Technical Service Bulletin: TSB101032

Boost Pressure Sensor Adapter Harness Resulting in Fault Codes 122/123

Figure 1, Boost Pressure Sensor and Adapter Harness Assembly, Part Number 4096902

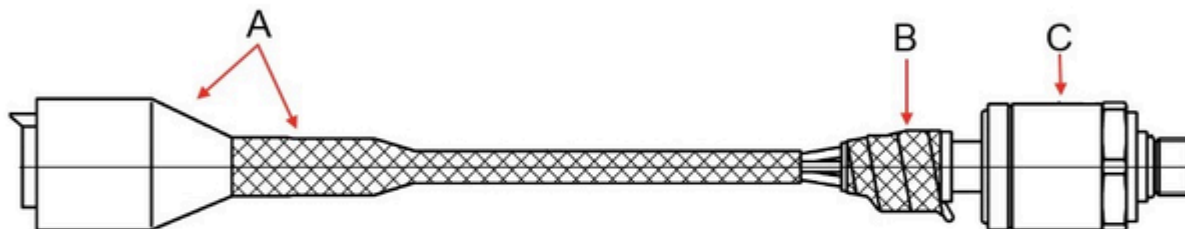
- Engine wire harness, Part Number 4096901
- Boost pressure sensor and adapter harness assembly, Part Number 4096902 (Figure 1)

A 3 pin Deutsch™ connector is included with the boost pressure sensor and adapter harness assembly to allow connection to the main engine harness.

Figure 3, Jumper Harness and Boost Pressure Sensor

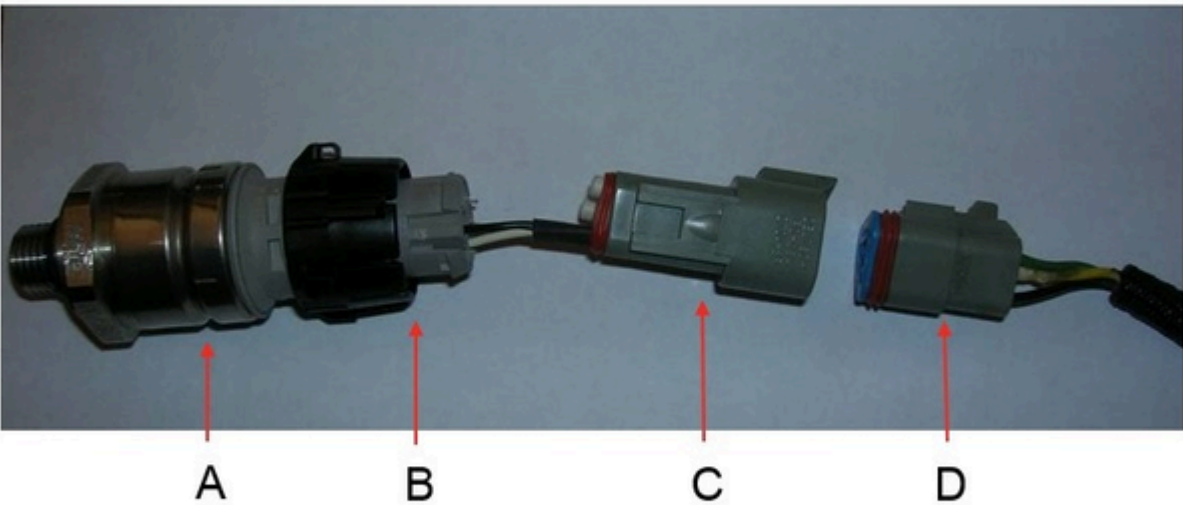
If the boost pressure sensor and adapter harness assembly, Part Number 4096902, is **not** available, the parts in Table 4 can be used to assemble a jumper harness to connect to boost pressure sensor, Part Number 3408589.

- Attach 3 pin Deutsch™ female connector (Figure 3, Item C) to the 3 pin Packard™ connector (Figure 3, Item B).
- Insert the 3 pin Packard™ connector into boost pressure sensor (Figure 3, Item A).
- Heat shrink **must** be applied around the harness and sensor connection to prevent movement.
